# **Planning Proposal – Amendments to Sydney LEP 2012 Sydney Metro Martin Place Station**

Submission to the NSW Department of Planning and the Environment  
1 December 2017

**City of Sydney**

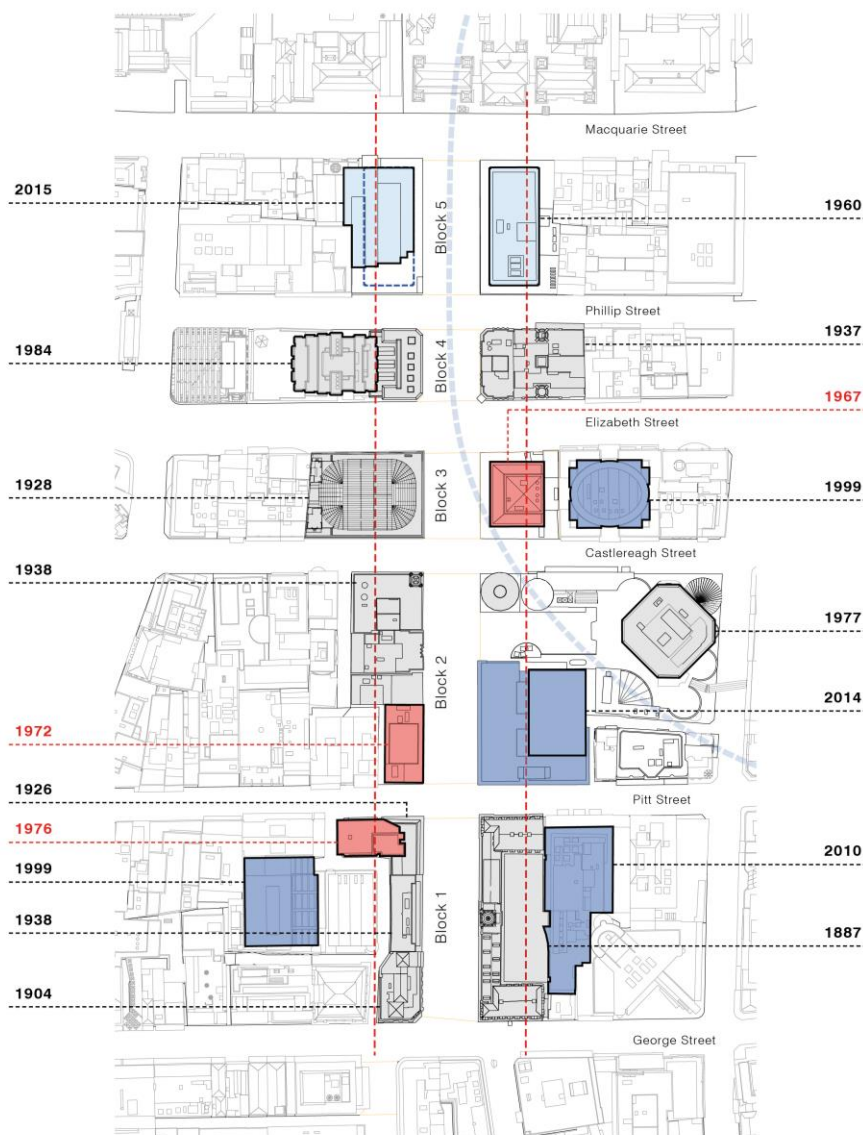
Figure 3 illustrates that only three sites, shown in orange, depart from the tower setback requirements and these date prior to the 1984 Gazzard Partners study. The South Site is one of these three sites, and its redevelopment is an opportunity to complete another part of the Martin Place long-term vision. The sites coloured blue have developed since 1984, and all respect the 25m or more tower setback. The sites coloured grey were developed before 1984, and again all respect with the tower setback.

Any new development at the South Site should observe the objectives and intent of the adopted controls, so that Martin Place continues to be distinguished from other streets as the civic and ceremonial heart of Sydney's community. This means that to ensure

- be built to the boundary with a 45m high street wall;
- if there is any tower development above 55m in height, it must be set back from Martin Place by 25m

FIGURE 4 – the prominence GPO clock tower is maintained by tower setbacks above 55m.

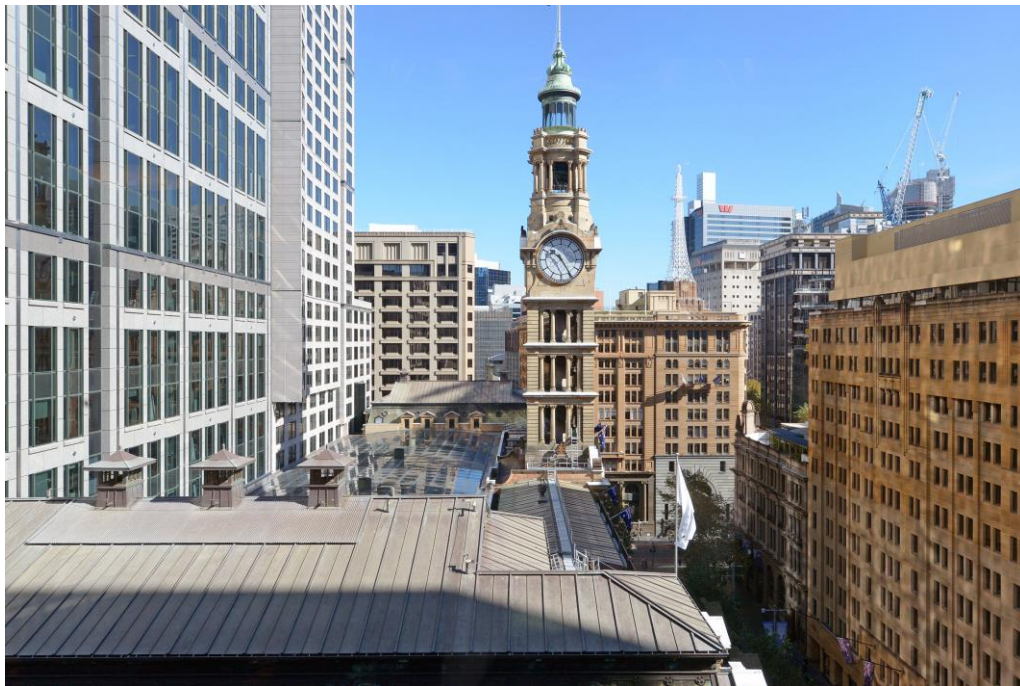
The urban design analysis supporting the planning proposal instead breaks Martin Place into a discontinuous series of fragments. It attempts to redefine the primary contextual relationship as being across each part of Martin Place, rather than along its length. It directly and intentionally downplays the role of the GPO clock tower. Recognising and maintaining the visual prominence of the GPO clock tower when viewed along Martin Place is a key aspect of the long-term vision.

Figure 9 – overshadowing of the MLC forecourt. The image is for 21 December, 10 am. The additional shadow caused by this planning proposal is shown in pink, and extends fully across the MLC forecourt. Refer to Figure 6 also.

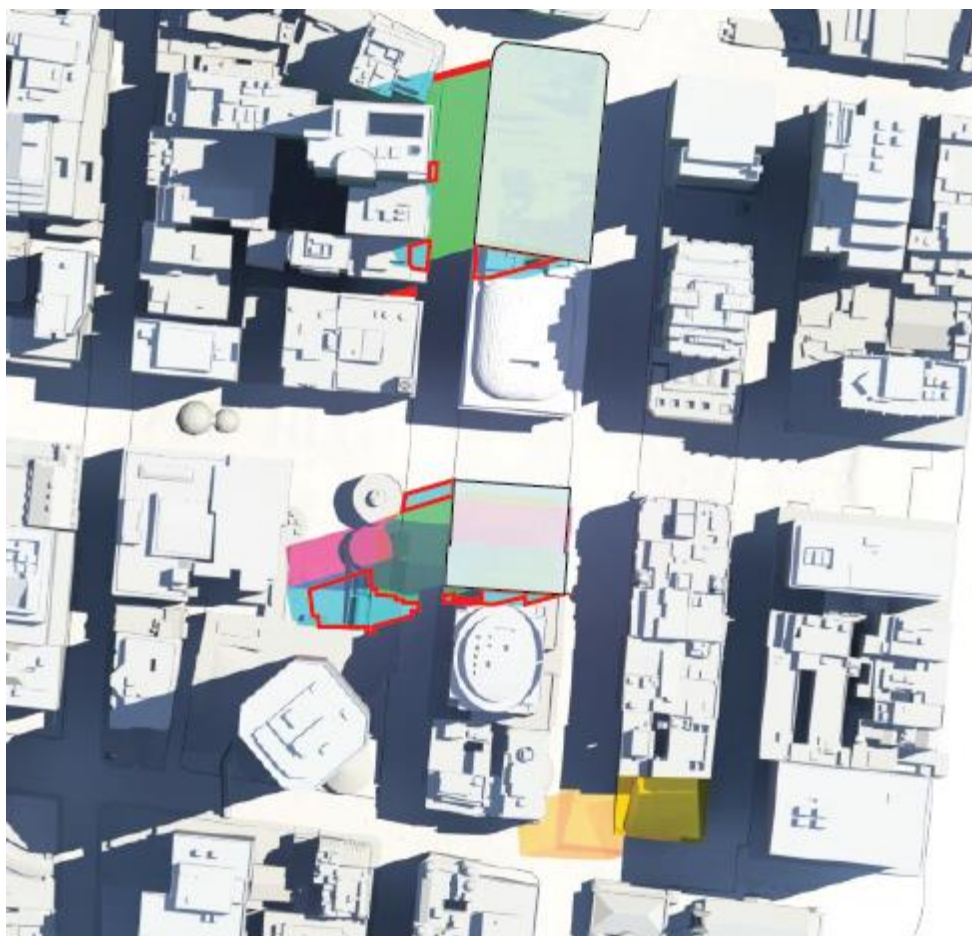
The planning proposal will cause significant additional overshadowing of a public forecourt at MLC. The 25m tower setback on the south site has the effect of allowing sun to the MLC steps and public forecourt, and through the skylights to the basement retail areas. By not respecting the setback it will cause additional overshadowing of this area. The overshadowing is produced by the component of the tower that is proposed within the 25m tower setback above 55m. The extent of the overshadowing is illustrated in Figure 9, showing shadow at 10am on 21 December. The MLC forecourt is well-used publicly accessible space along Martin Place (Figure 6). The planning proposal should not cause overshadowing that affects rare public amenity.

Figure 11 – setbacks

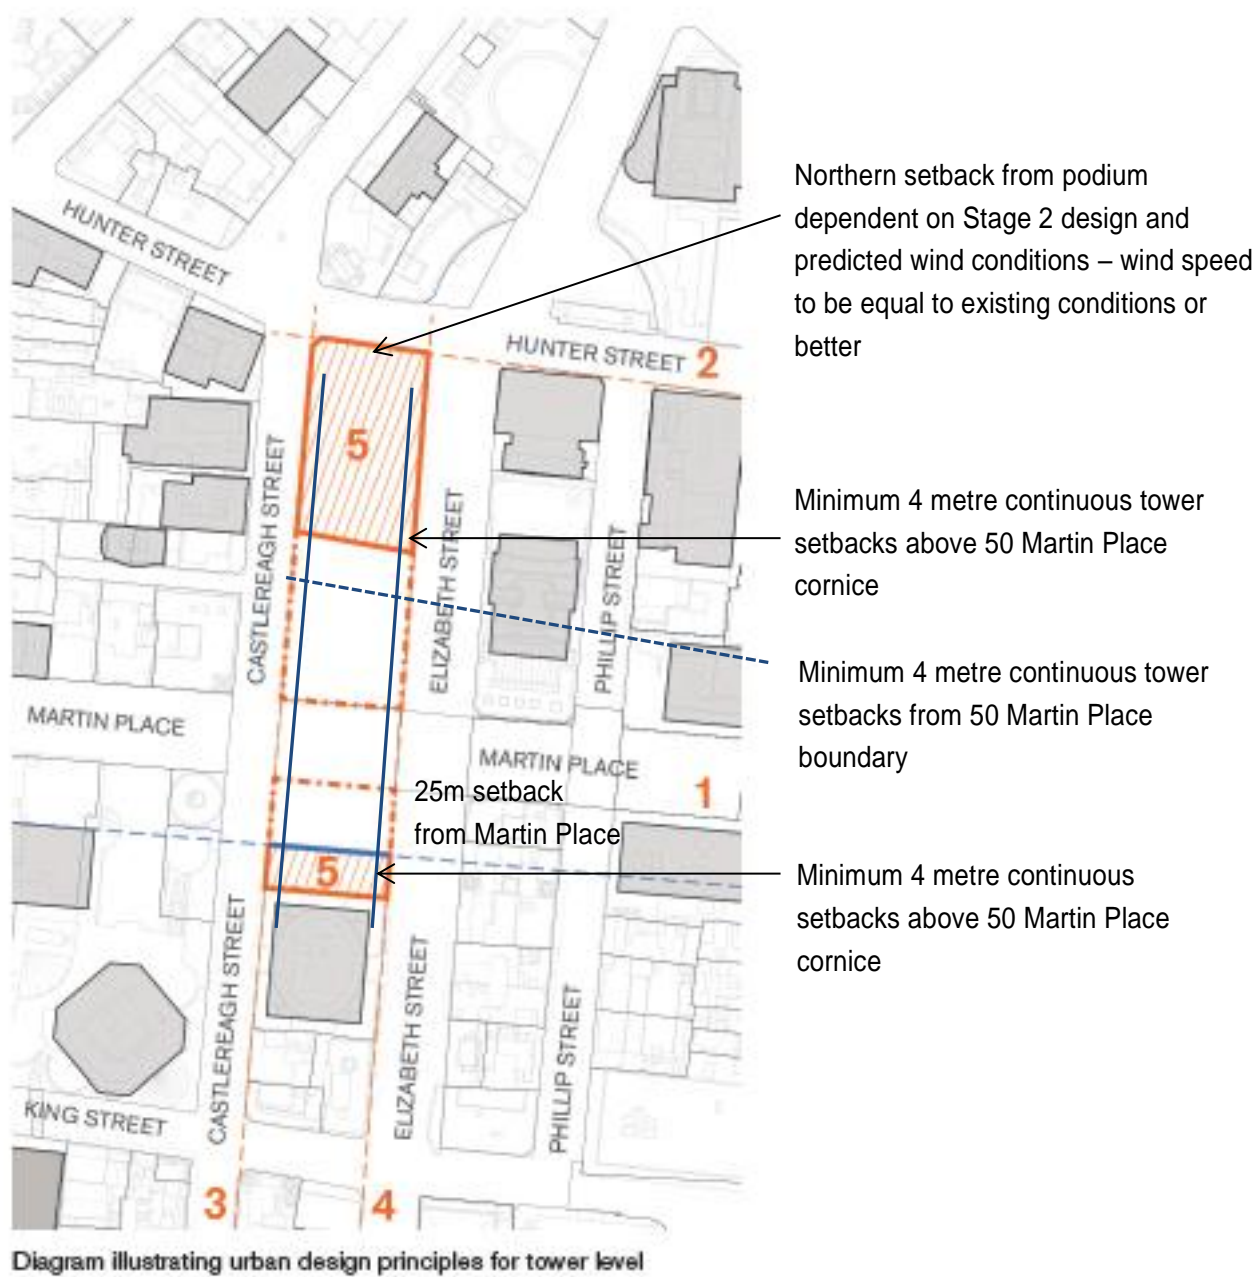
The North site should have an FSR that is matched to the desired above-ground form of any building on the site. This is not the case for the North Site in the planning proposal, and needs to be sensitively revised. The built form considerations that should inform any revised FSR on the North site include:

- A maximum building height below the Martin Place sun access plane. The planning proposal is consistent with this principle
- A street wall height that relates to and reinforces the scale of 50 Martin Place. The planning proposal is not consistent with this principle
- Setbacks of at least 4 metres above this street wall to Elizabeth Street and Castlereagh Street for the full length of the building, to allow light, air circulation and daylight to adjacent development and to the public domain, and to provide wind protection. The planning proposal is not consistent with this principle
- A street wall setback should be required to Hunter Street if the modelled wind conditions exceed existing conditions. The planning proposal is not consistent with this principle.

**The FSR for the North site needs to be reviewed to be consistent with the above considerations.**
